ADDENDUM NO. 8 TO PROJECT NO. 44578

CONSTRUCTION WORK - PLA
MAJOR BUILDING RENOVATIONS FOR THE
MANHATTAN FORENSIC
RELOCATION
MANHATTAN PSYCHIATRIC CENTER
600 EAST 125th STREET
WARDS ISLAND, NY 10035

September 29, 2015

TENTH FLOOR DEMOLITION AND WINDOW INSTALLATION PLAN

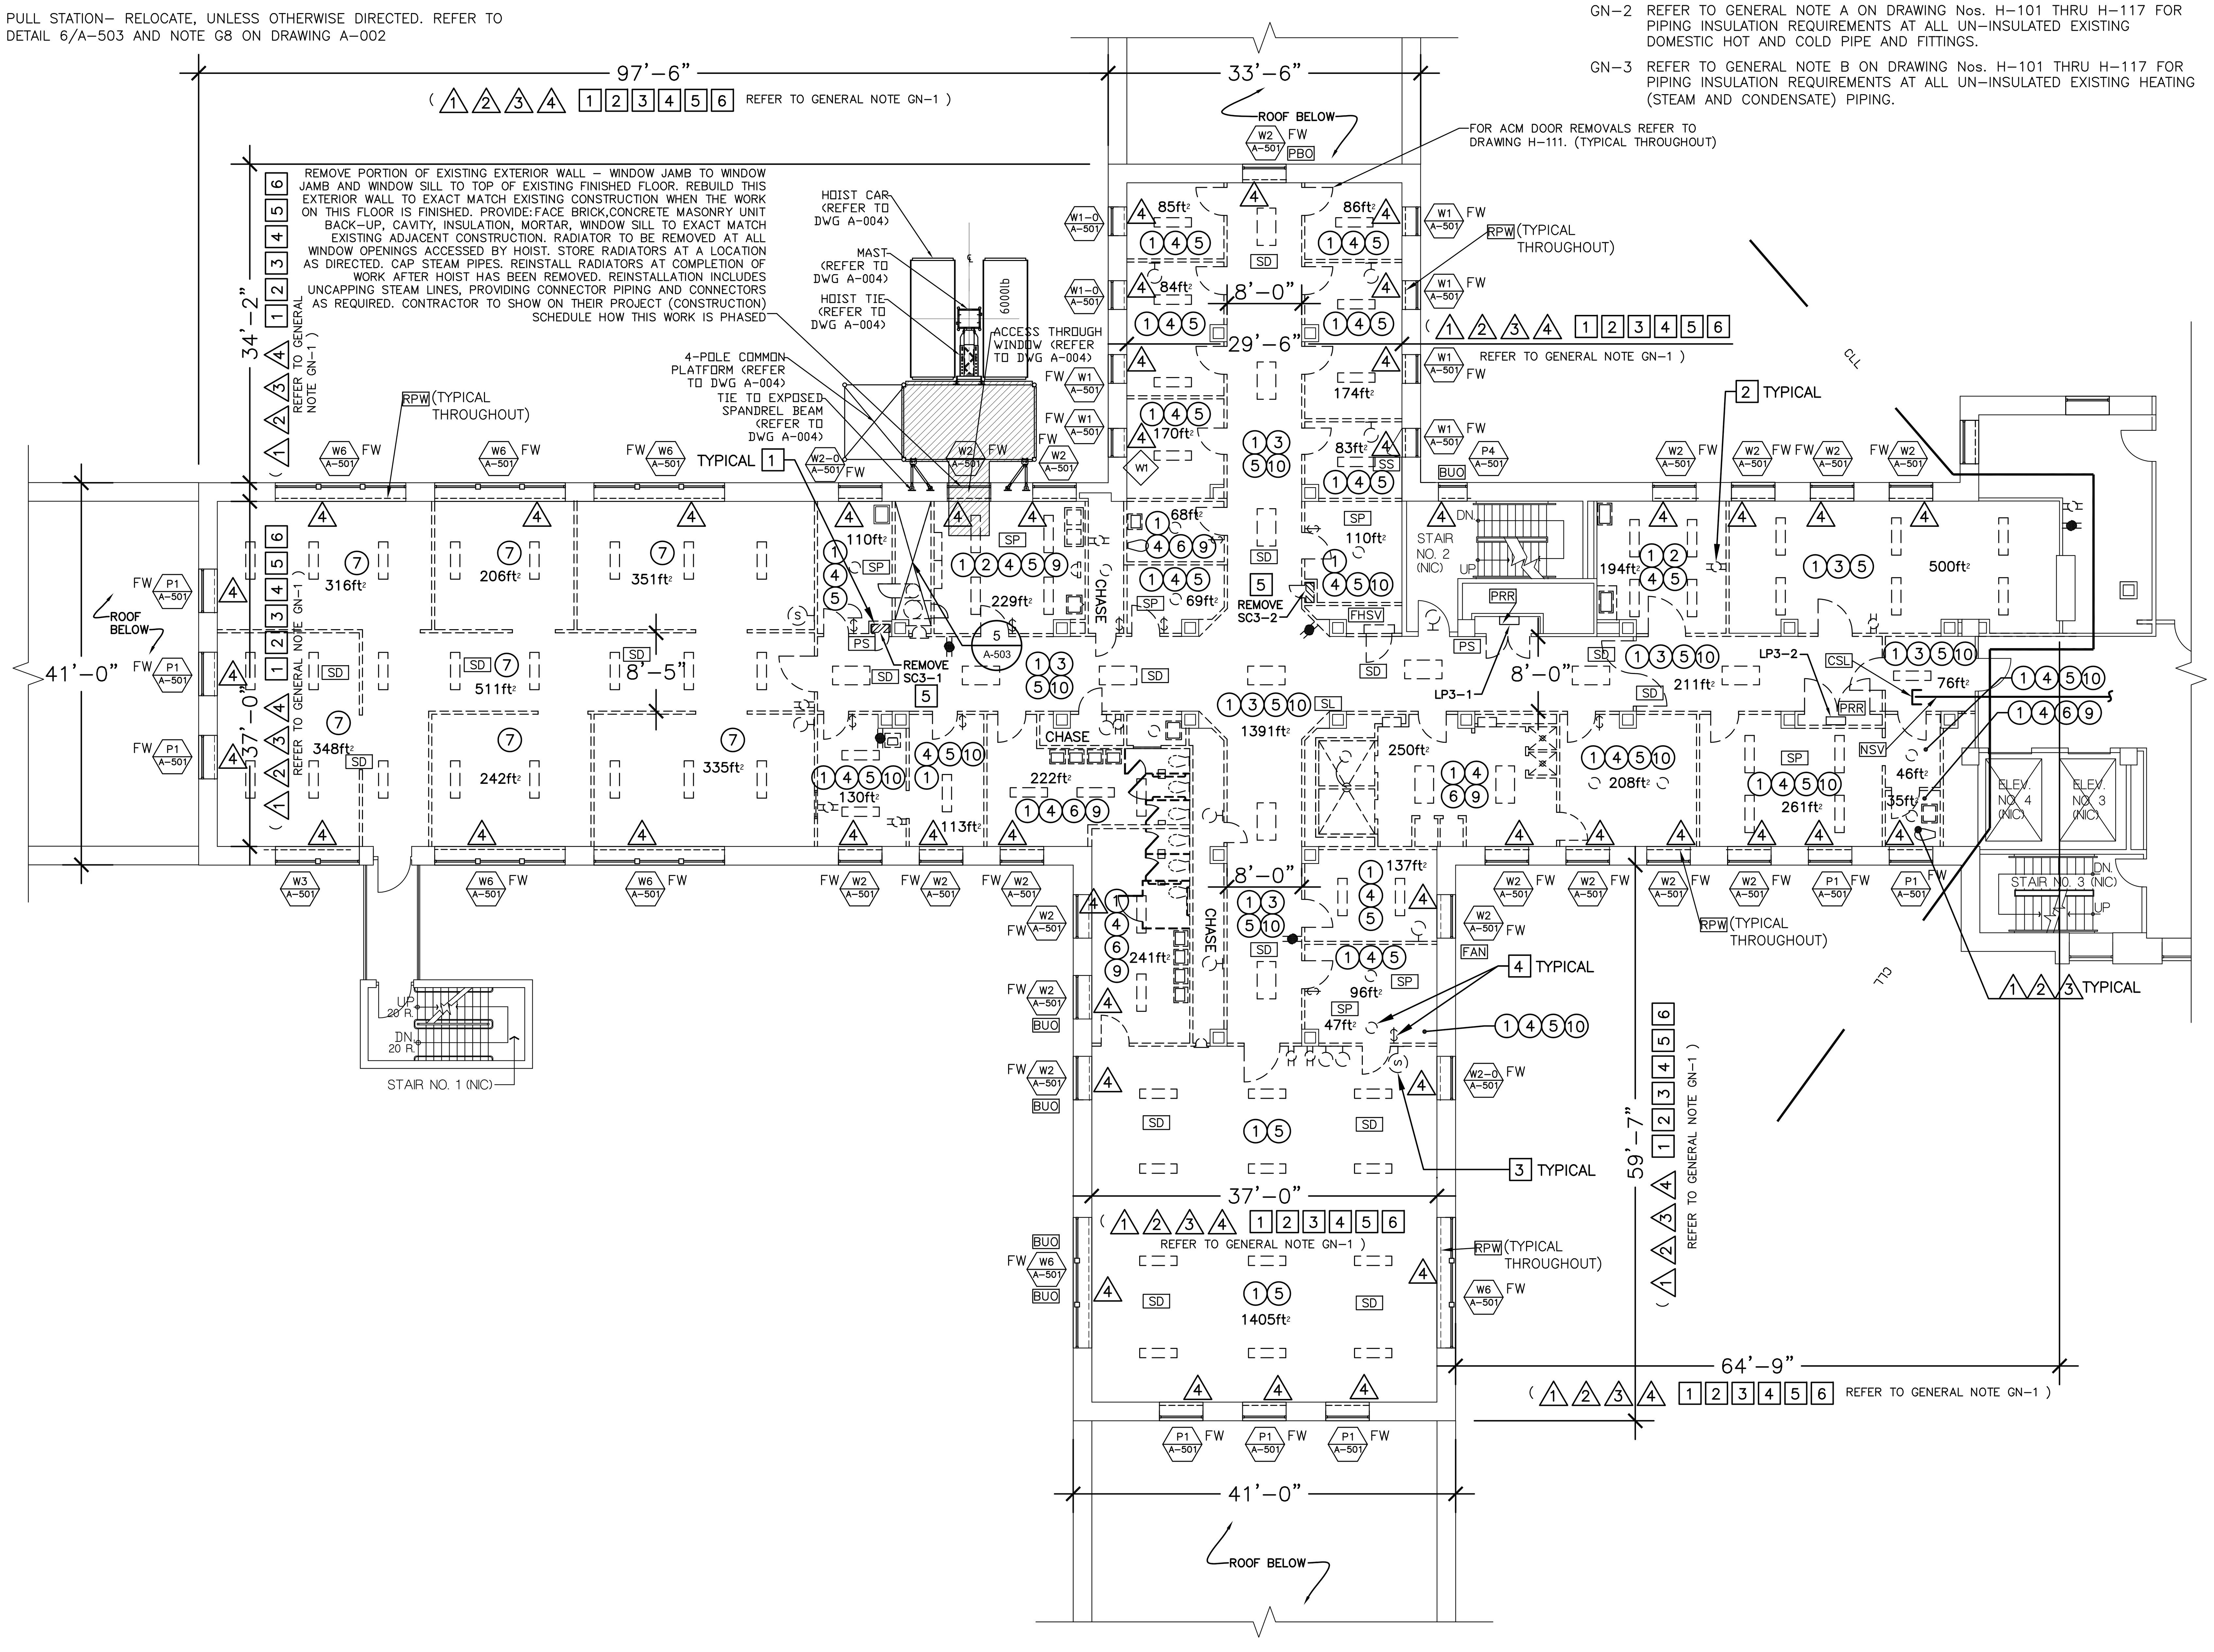
45. Revised Drawing (issued with Addendum #5) No A-110-2:
    a. Revise Room names for 1034A and 1047A from “Passage“ to “Secure Corridor”.
    b. Delete detail tag 8/504-2 at column line H between 1 and 2, and at column line 10 between N and O.

ELEVENTH FLOOR WINDOW INSTALLATION PLAN
3/32" = 1'-0"

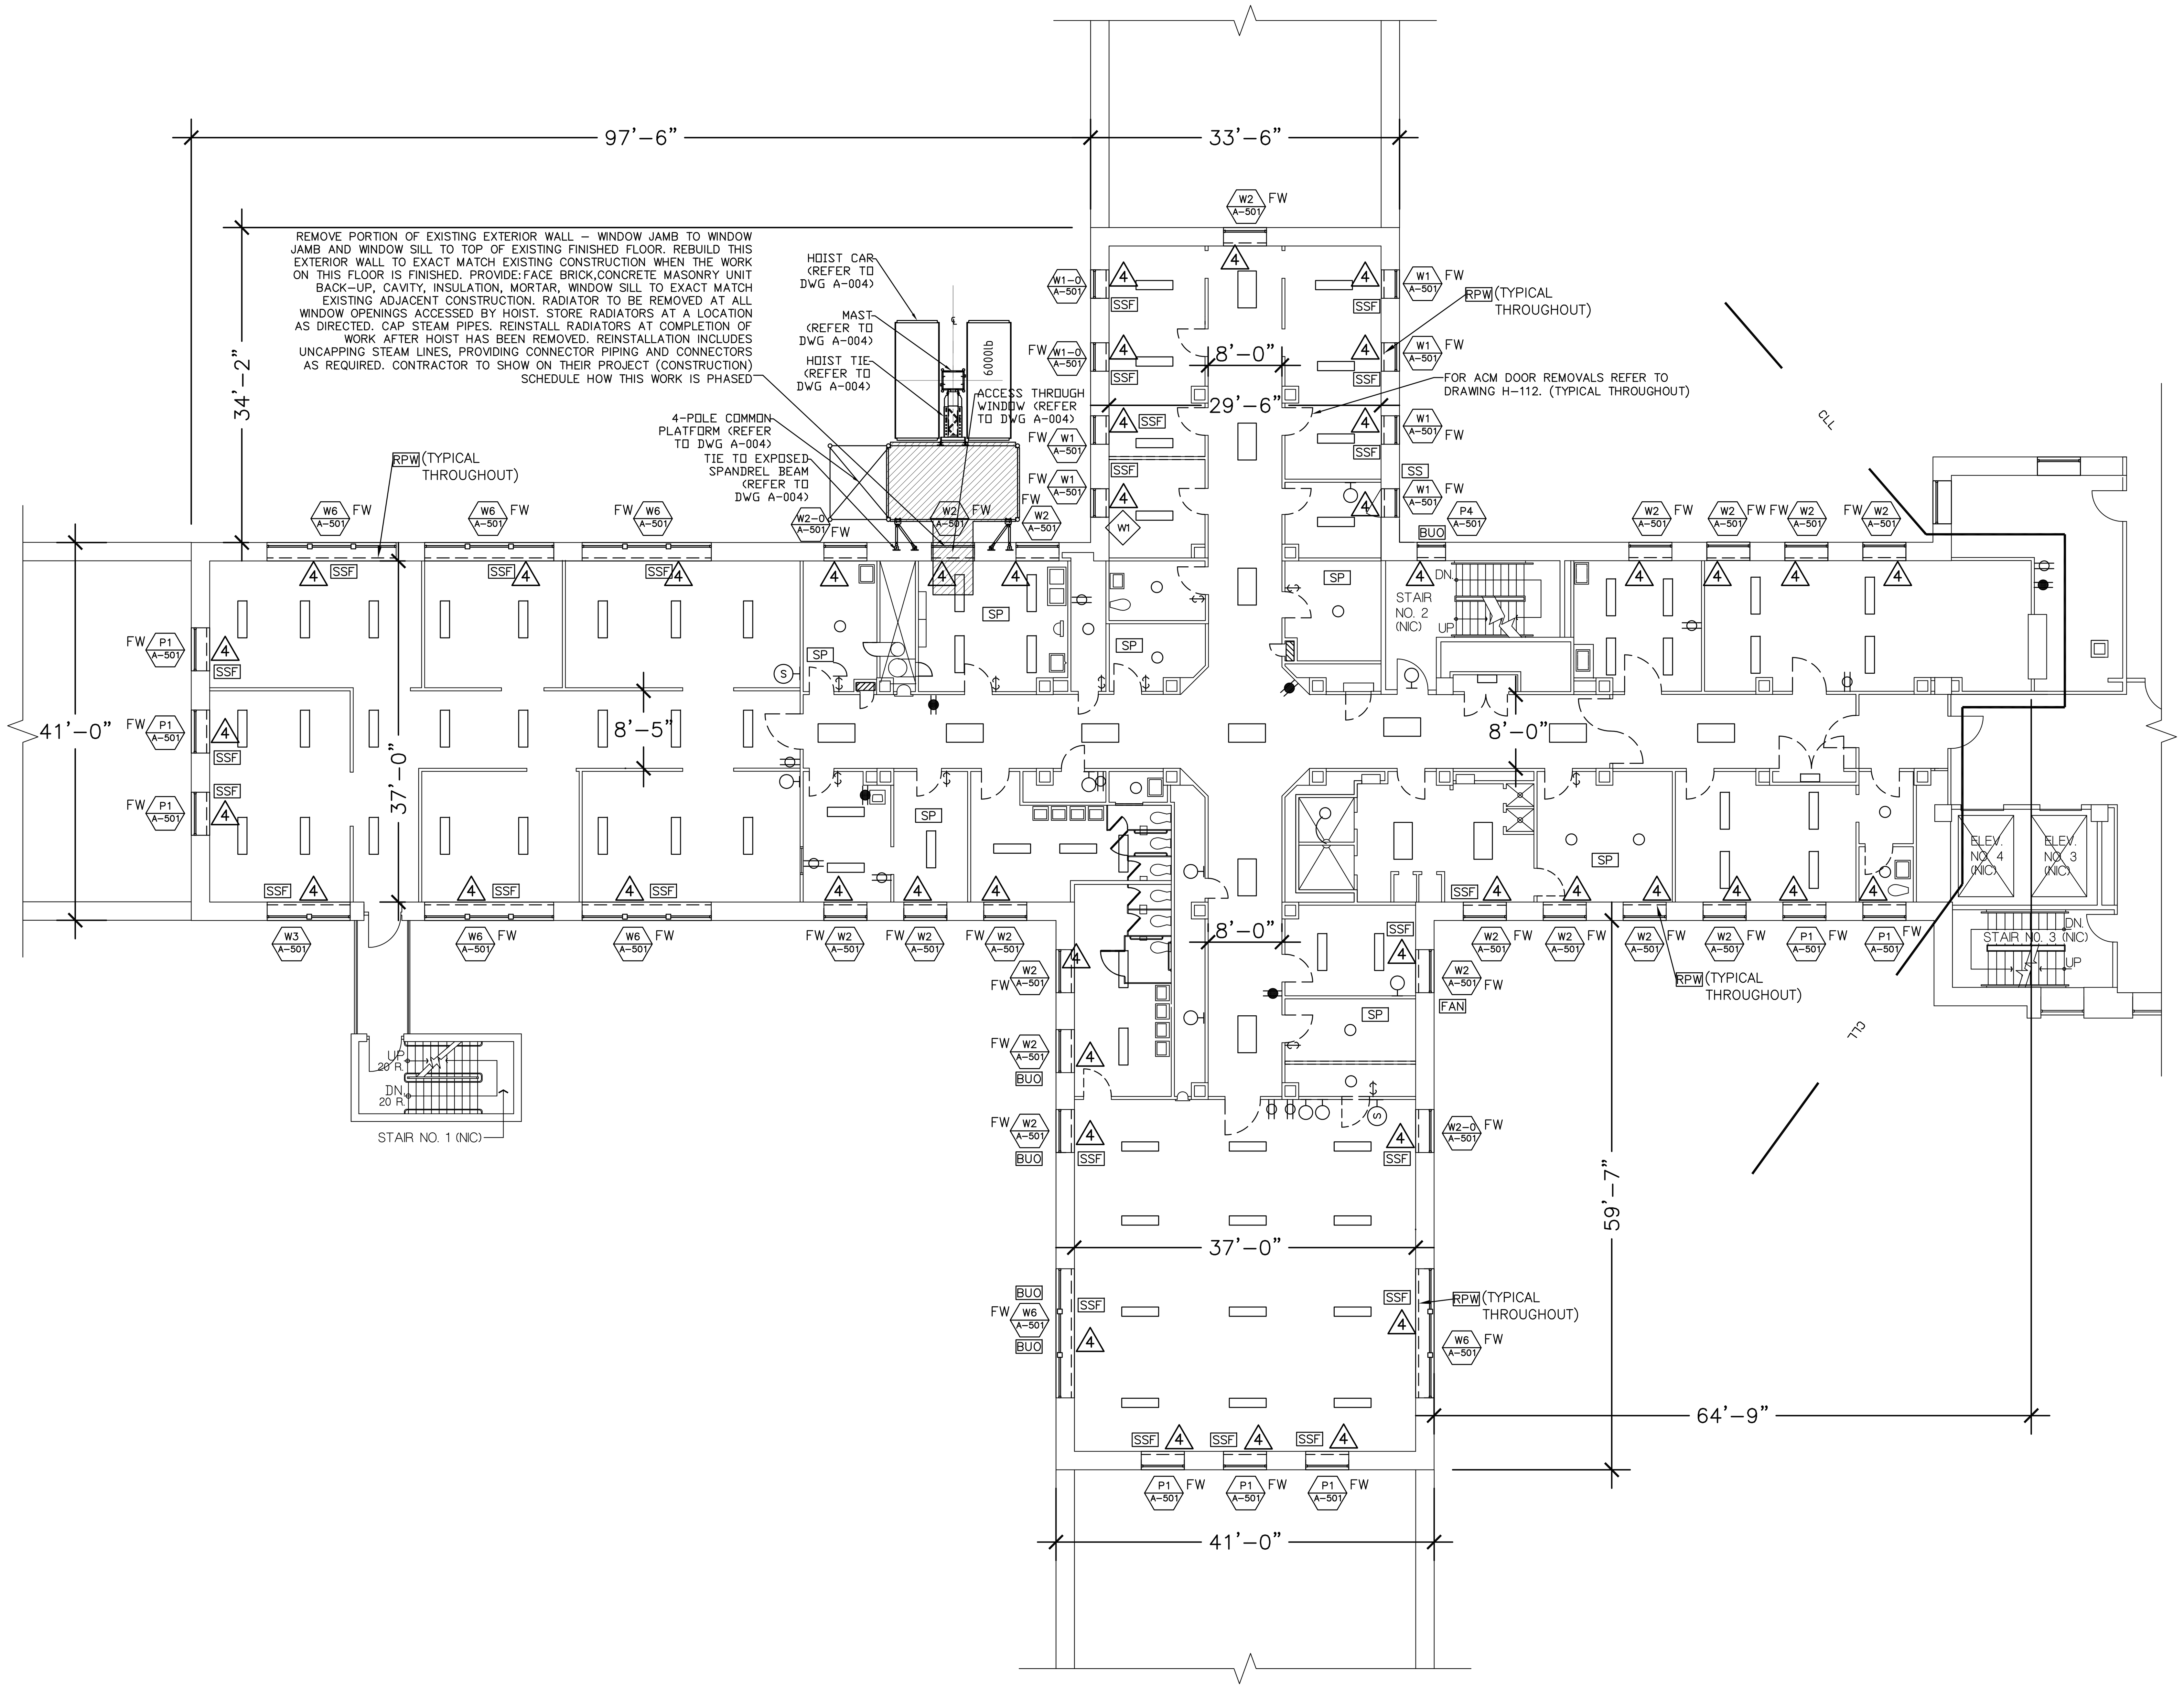
46. Revised Drawing (issued with Addendum #5) No A-111-2:
    a. Revise Room names for 1134A and 1147A from “Passage“ to “Secure Corridor”.
    b. Delete detail tag 8/504-2 at column line H between 1 and 2, and at column line 10 between N and O.
